## Product Change Notification (PCN)

series 082-1

PLCC-SMD Socket 1,27mm Series 082 Variant 1

Variant	old version	new version
082-1	 <p>4.60±0.10 4.0±0.1 3.4±0.1 SEC B-B</p>	 <p>4.75±0.20 4.0±0.1 3.4±0.1 SEC B-B</p>

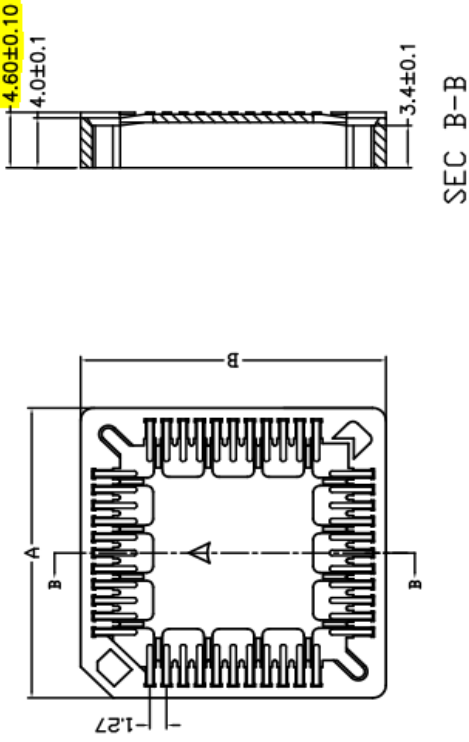
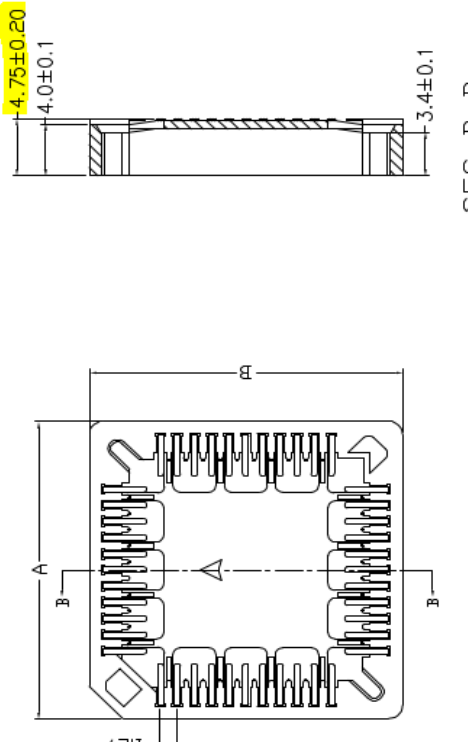
change of dimension 4,60mm to 4,75mm

revision of tooling
